CITY OF ST. AUGUSTINE HISTORIC ARCHITECTURAL REVIEW BOARD

AMENDED

THURSDAY, JANUARY 16, 2025 - 1:00 PM

Existing home with proposed tile

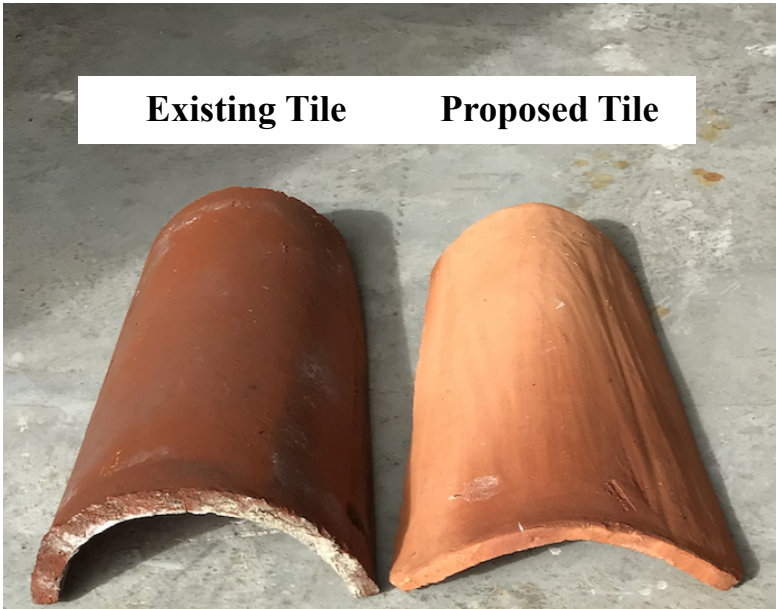
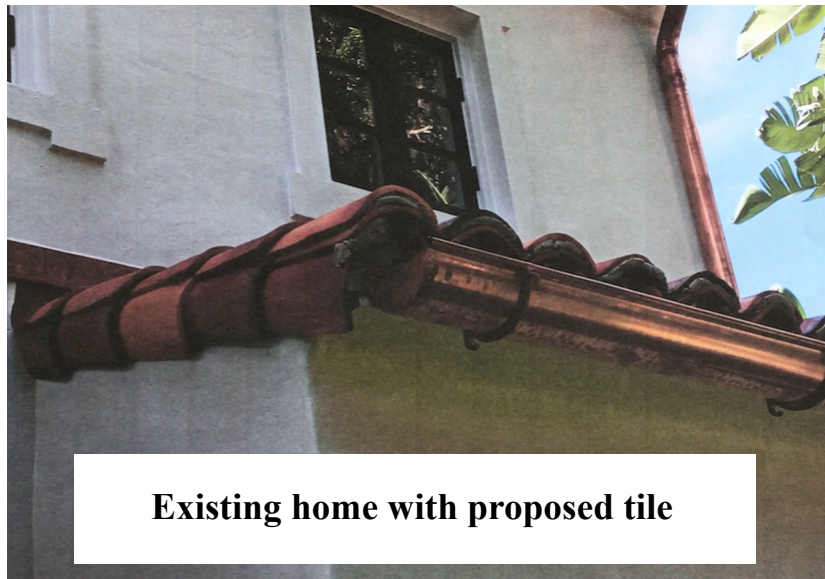
Replace original Spanish Clay Tile (9.5" W x 18.25 L x 4.25 H) North wing and Concrete tile on South Wing with similar style Santa Fe Artisan Blend, handmade clay tile (9.5" W x 18.25" L x 3"H).

Thank you for your replies. I guess that is the thing that may stick out the most is the change from the barrel (which seems to be on the original) to the cap and pan (which may have been how the concrete tiles were laid). Was there a reason to go with the cap and pan configuration? Did that have anything to do with resiliency or just the desired look?

Good Morning! We are replacing existing with ‘barrel’ tiles. From what I’m reading ‘cap and pan’ tiles are 2 different tiles, the pan being flatter. We are using the same tile, one facing up, one facing down. This is exactly how the original was installed. And the reason for replacing was the leaks combined with insurance ‘not liking’ 2 different tiles, clay and concrete, but mainly the leaks. I chose these specific tiles as they are a better quality, hand made, more substantial clay tile than any other we had access to. I’m available to talk this morning if you have any other questions. Jennifer
